<b>Docket Number:</b>	16-AFC-01
<b>Project Title:</b>	Stanton Energy Reliability Center
<b>TN #:</b>	217681
<b>Document Title:</b>	Response to Staff Data Requests A1-A5
<b>Description:</b>	Responses to South Coast Air Quality Management District Comments on AFC Section 5.1, Air Quality
<b>Filer:</b>	Douglas Davy
<b>Organization:</b>	CH2M
<b>Submitter Role:</b>	Applicant Consultant
<b>Submission Date:</b>	5/22/2017 1:14:49 PM
<b>Docketed Date:</b>	5/22/2017

**Subject: Stanton Energy Reliability Center (16-AFC-1)  
Stanton Energy Reliability Center, LLC's Response Response Staff Data Requests A1-A5 and  
Responses to South Coast Air Quality Management District Comments**

**Subject: Stanton Energy Reliability Center (Facility ID# 183501) Response Package to the SCAQMD February 24<sup>th</sup>, 2017 Comment Letter**

**Figure 1 Locations of Schools**

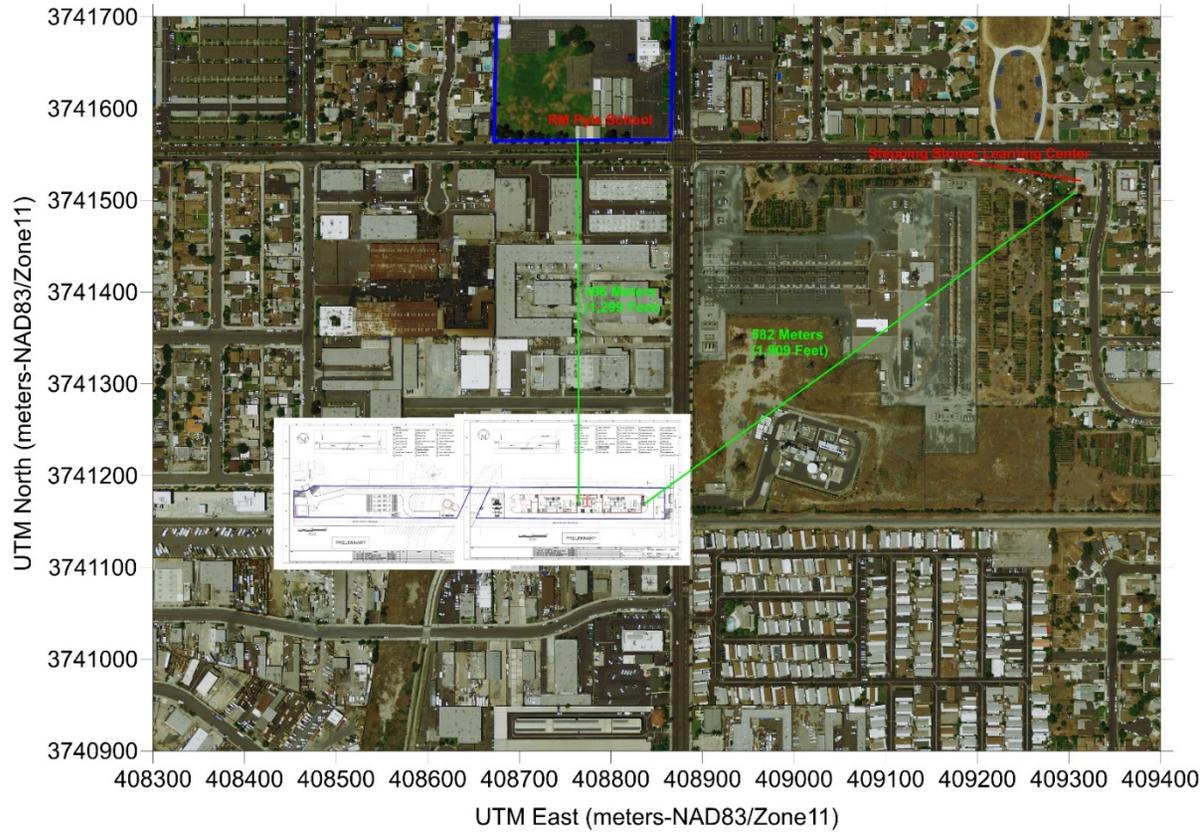
c. The response to 15.a. indicates School 1 - R.M. Pyle Elementary is 1050 ft from the site, as measured from the northern site boundary to the school southern boundary. Since the distance is very close to the threshold of 1000 ft, please provide the following additional information:

i. Please provide a map showing the nearest equipment for the SERC, the outer boundary of R.M. Pyle Elementary and the distance between the two.

*In addition, the Pyles Elementary School was included as a school site receptor (shown as Nearest School 1 in Table 5.9-8) in both the original and revised HRAs. Please note that the distances on sensitive receptor list are from the center of the SERC project site to the approximate center of each identified sensitive receptor location, i.e., not the distance from SERC site boundary to receptor boundary. For both the Pyles Elementary School and the Stepping Stones Learning Center, the approximate distance from the nearest exhaust stack to the receptor boundary are shown in Figure 1 attached to this letter.*

*Response: Figure 1, derived from the Project Description of the AFC, shows the project site boundary and equipment location. The southern school property boundary of Pyles Elementary School (outlined in blue in Figure 1 below) lies adjacent to the north side of W. Cerritos Ave. The map scale is projected to Universal Transverse Mercator North American Datum 83. The distance between the project stack location and the Pyles Elementary School's southern boundary is 396 meters (~1,299 feet). The address of the school is:*
